DEVELOPMENT APPLICATION ASSESSMENT REPORT

Application Number:	DA2020/0346
----------------------------	-------------

Responsible Officer:	Adam Urbancic
Land to be developed (Address):	Lot 3 DP 11547, 62 Wakehurst Parkway NORTH NARRABEEN NSW 2101
Proposed Development:	Demolition works and construction of a dwelling house including a swimming pool
Zoning:	E4 Environmental Living
Development Permissible:	Yes
Existing Use Rights:	No
Consent Authority:	Northern Beaches Council
Land and Environment Court Action:	No
Owner:	Mark Amdrew Woolf Peta Helen Woolf
Applicant:	Peta Helen Woolf

Figure 1: Extract from Drawing No. A7, Rev D depicting the building envelope non-compliance on the eastern elevation.

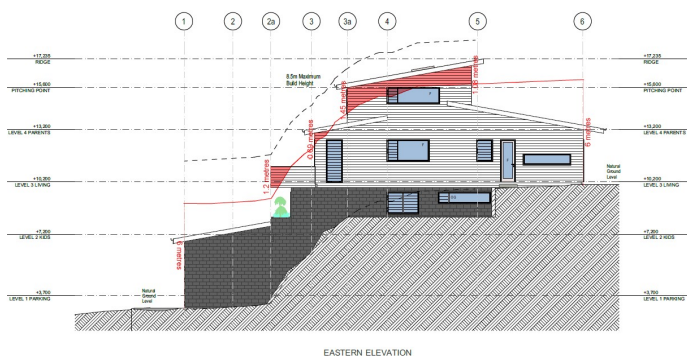
The proposed development protrudes the prescribed building envelope on the eastern and western elevations, as depicted on Figures 1 and 2 respectively.

The control allows for a variation to be considered on a merit basis where the building footprint is situated on a slope over 16.7 degrees or 30%, which is applicable in this case.
